Regular Town Council Meeting

December 4, 2023

1. LDR Text Amendment to Neighborhood High Density-1 Zone (P23-168) (Tyler Valentine) -
This item will be continued to 1/8.
2. Development Plan for Mixed Use Building at 655 and 665 S. Cache Street (P23-105)
(Katelyn Page)

C3.2

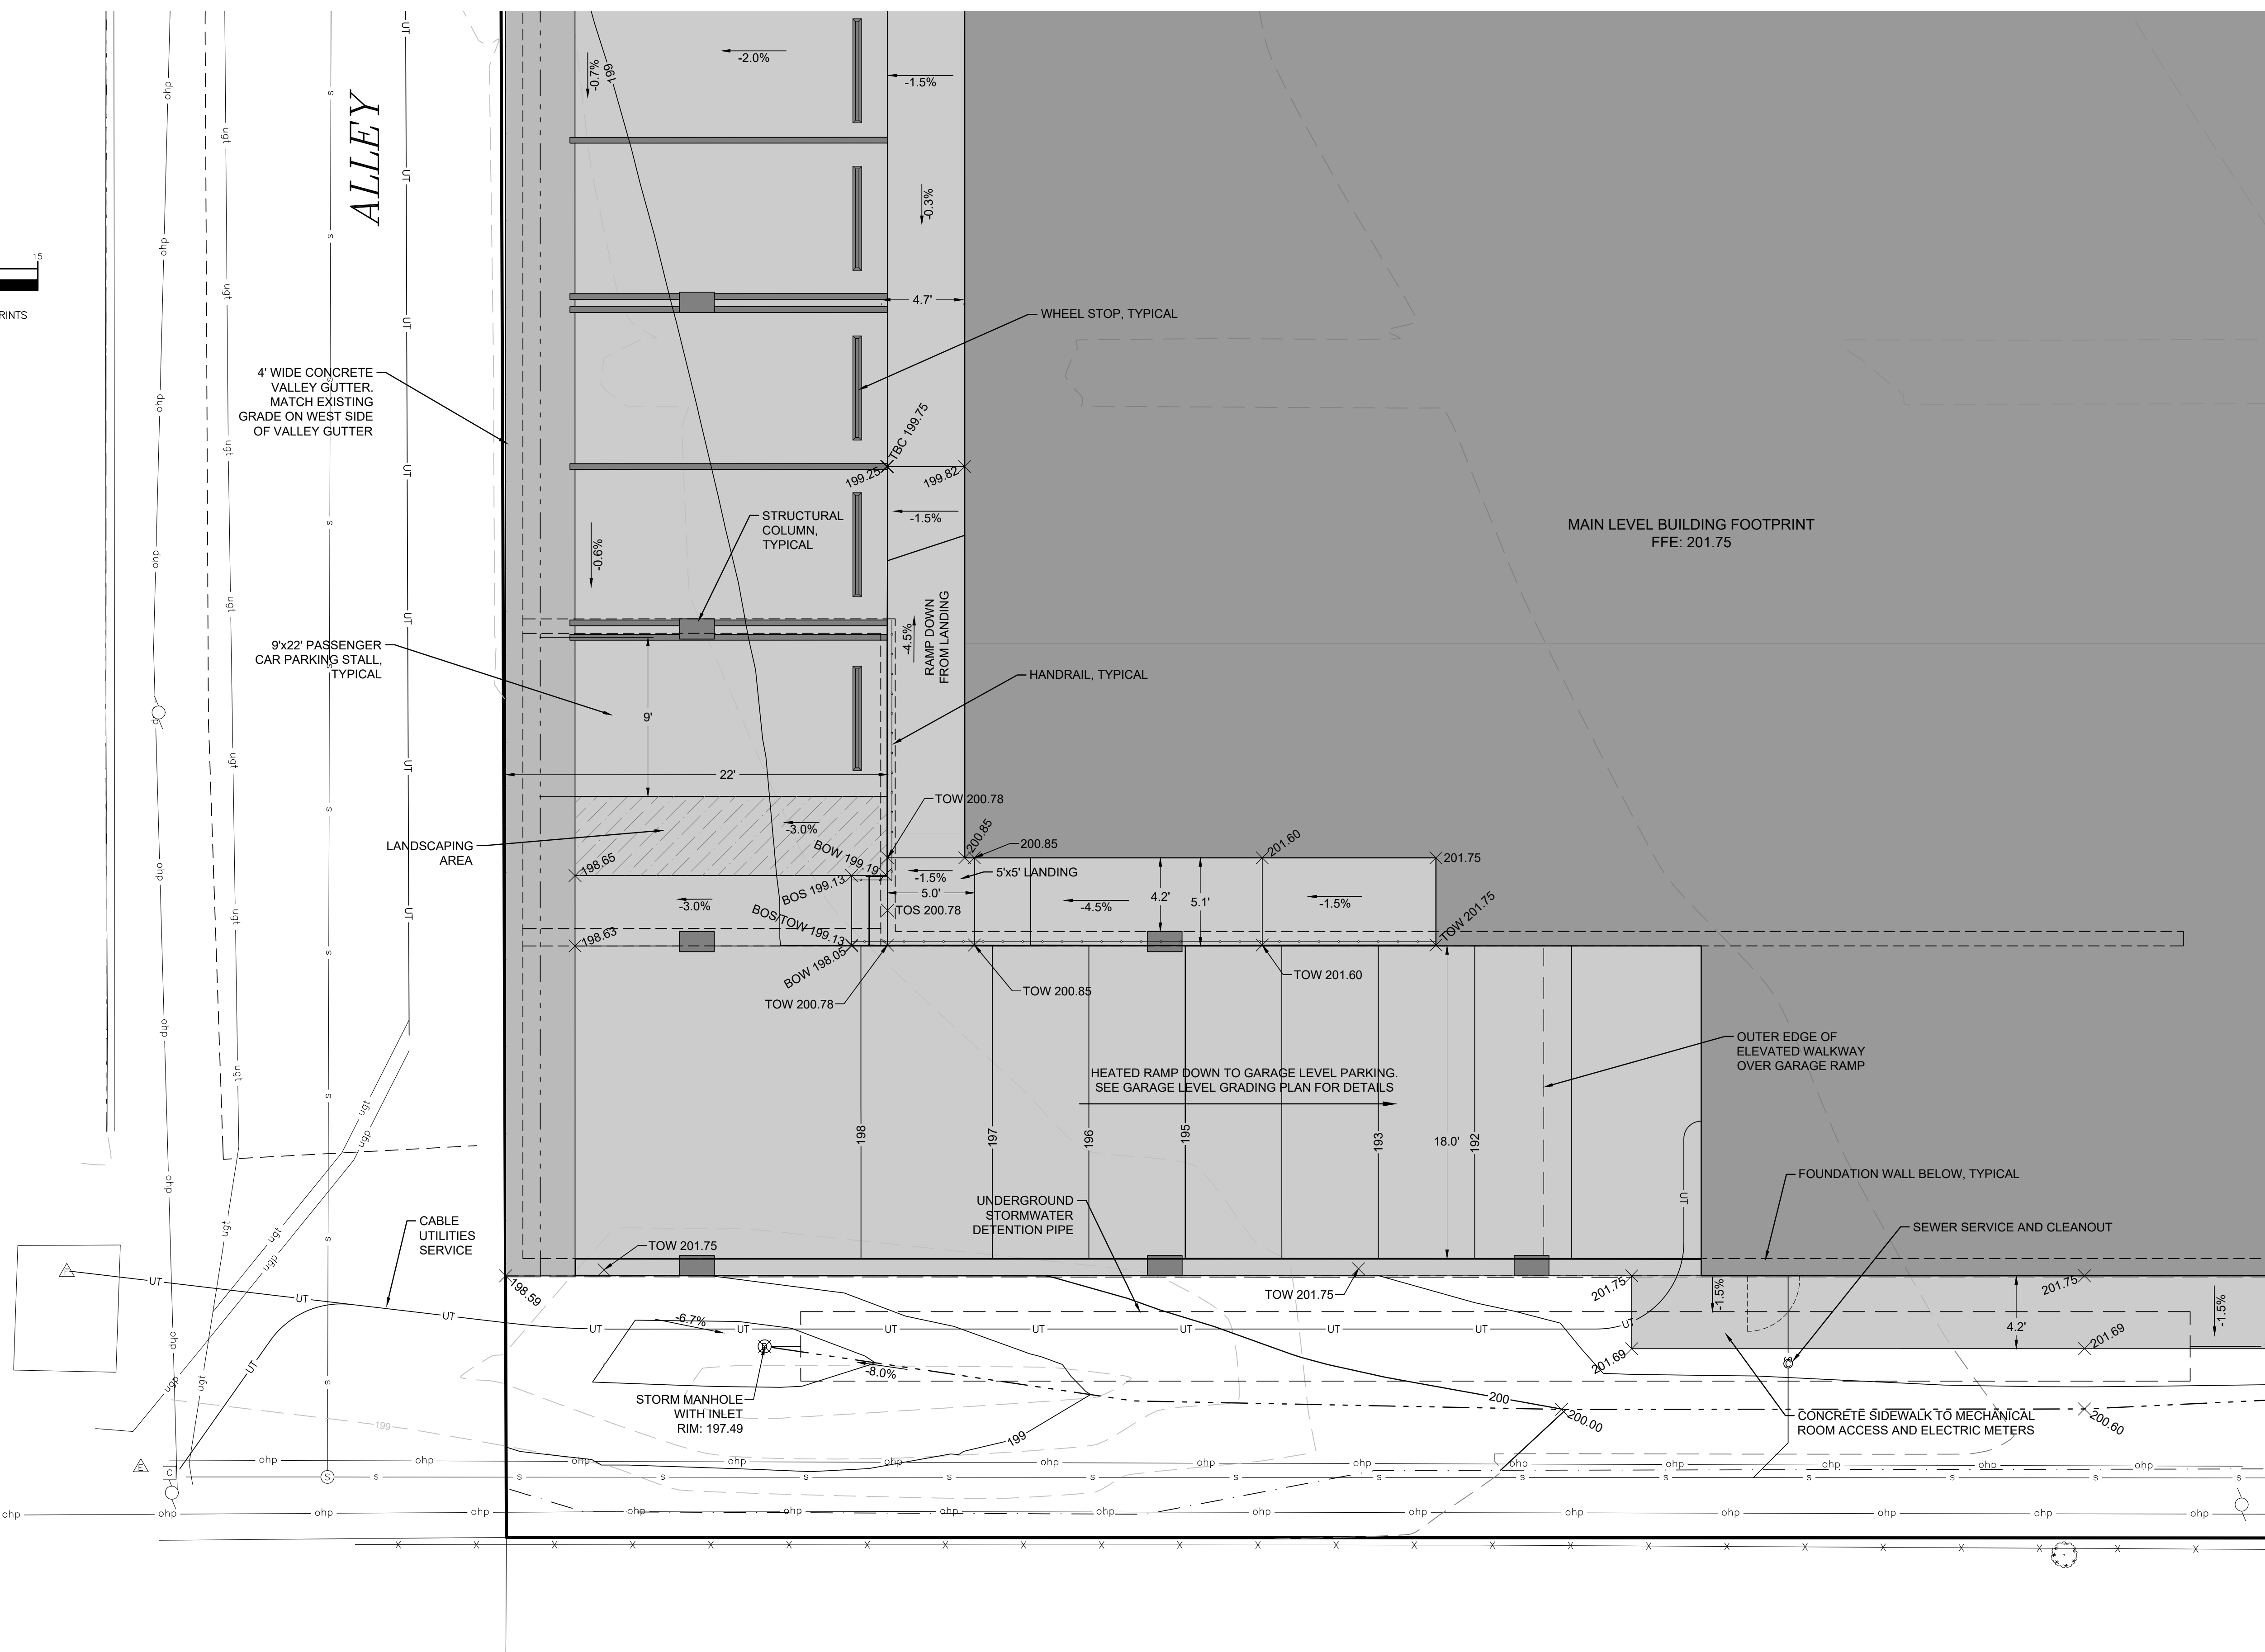
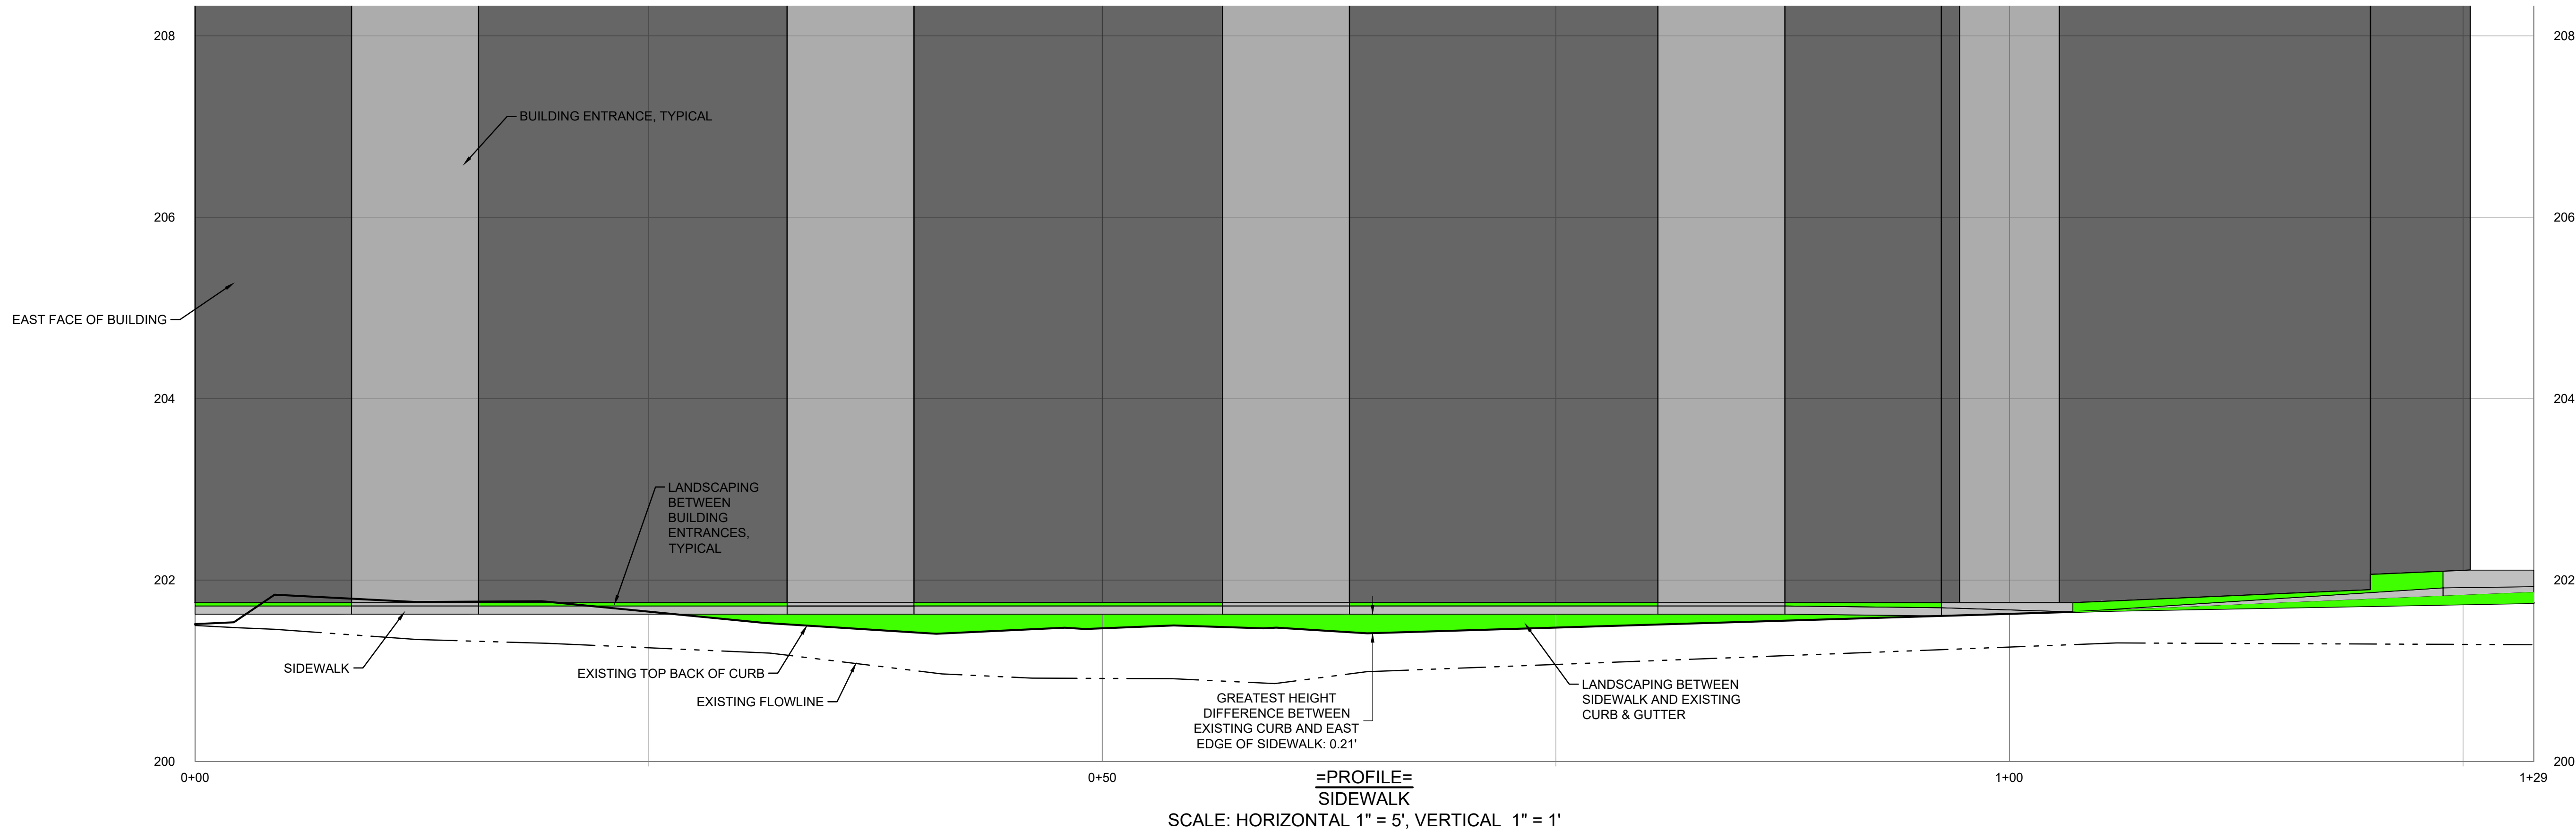
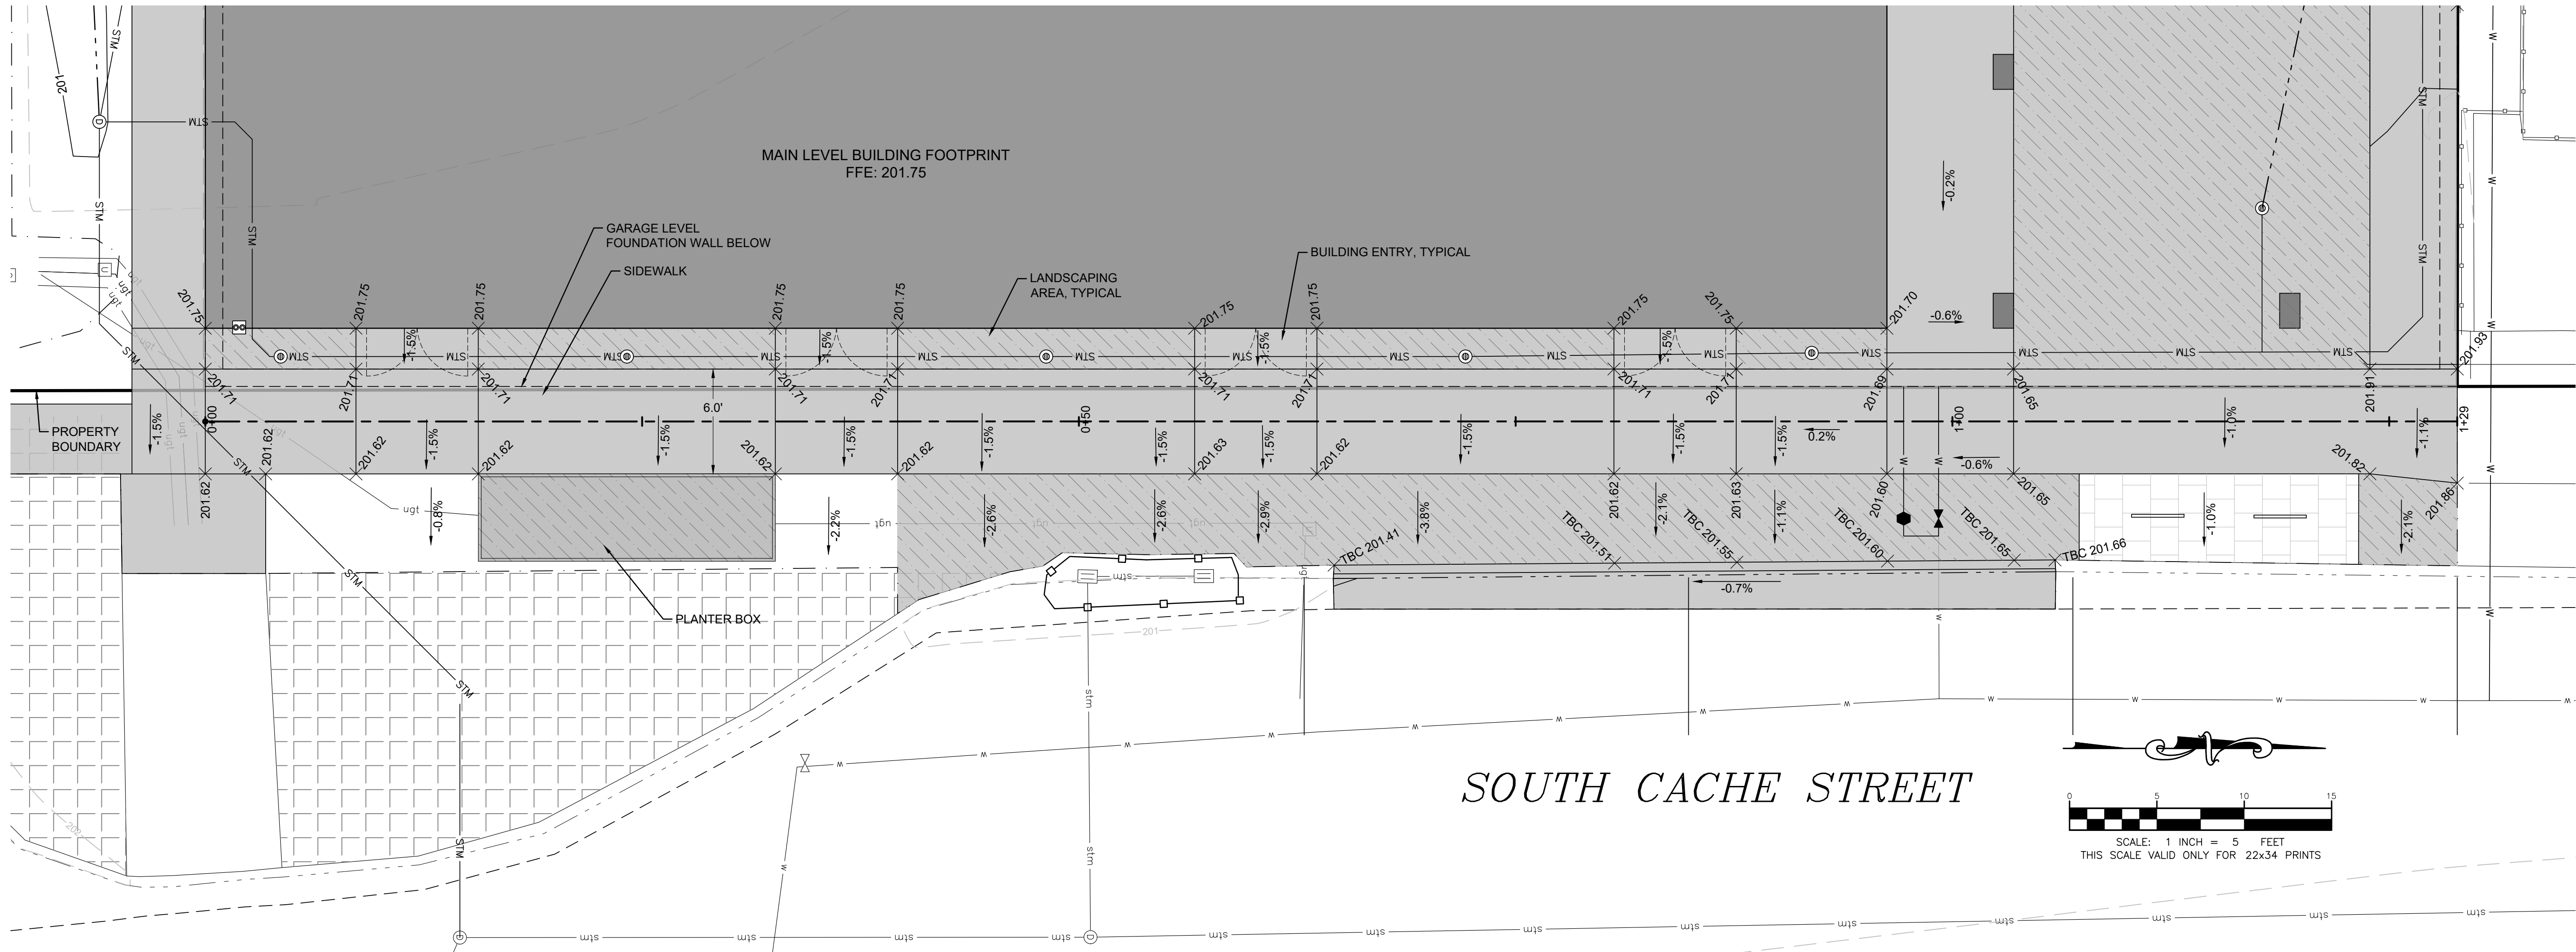
Verify structure setback to northern property line. Applicants LDR compliance table references 5 but A102 references 3-6 and civil C3.2 references 3.5 to structure. This setback is measured to structure and not to site development. See comment below on minimum sidewalk width.

Verify structure setback to eastern property line. Applicants LDR compliance table references 0 but A102 references 3-4 and civil C3.2 references 2.4 to a point that is not the actual structure. Staff notes location of property line is unclear on civil plan.
